Addendum No. 2

PROJECT NAME: RUTLAND SOUTHERN VERMONT REGIONAL AIRPORT
 CLARENDON, VERMONT
 PROJECT NUMBER: AV14-8018-300
 FILE NAME: z07h124xs_rsa6.dgn
 PROJECT LEADER: F. WALSH
 DESIGNED BY: G. D'AMICO
 RSA CROSS SECTIONS
 PLOT DATE: 6/13/2013
 DRAWN BY: M. KEMP
 CHECKED BY:
 SHEET 35 OF 36

PROJECT RECORD DRAWINGS

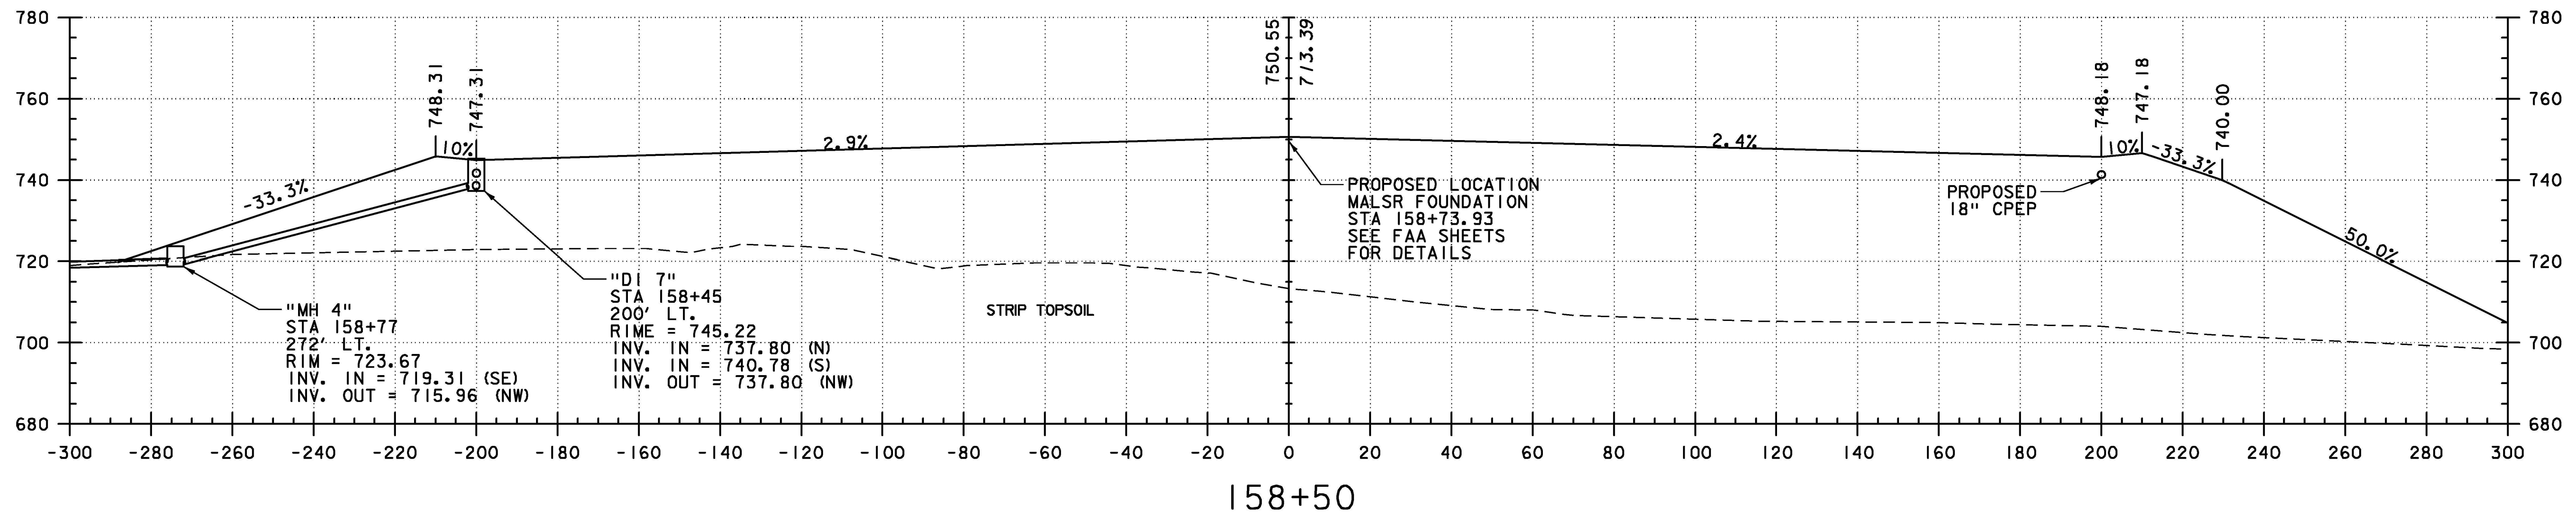
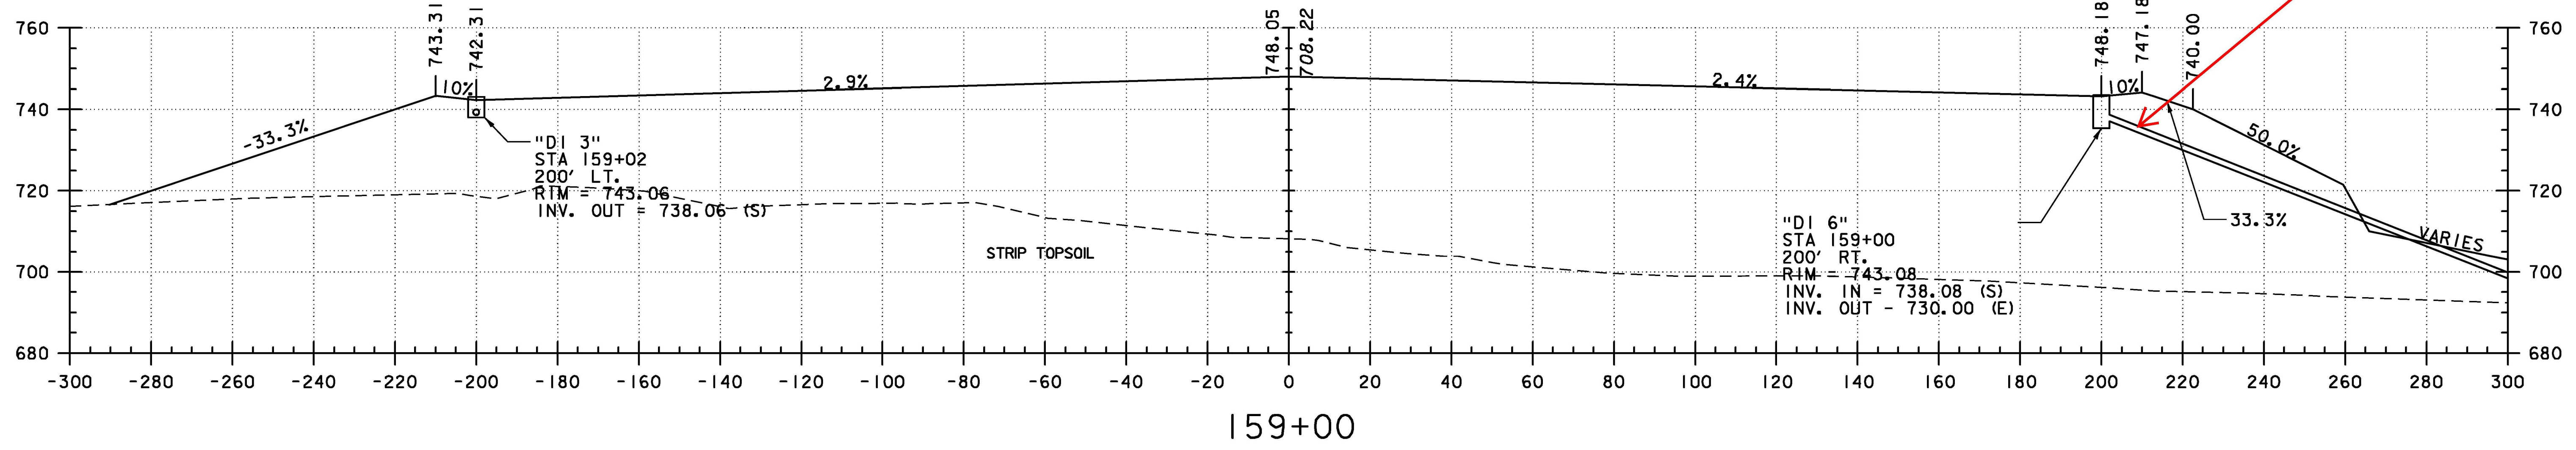
Record Drawing
 Finished grades are shown on
 Attachment A: Construction Survey
 Record Plan

See Drainage Plan
 for modifications to
 stormwater in this
 vicinity
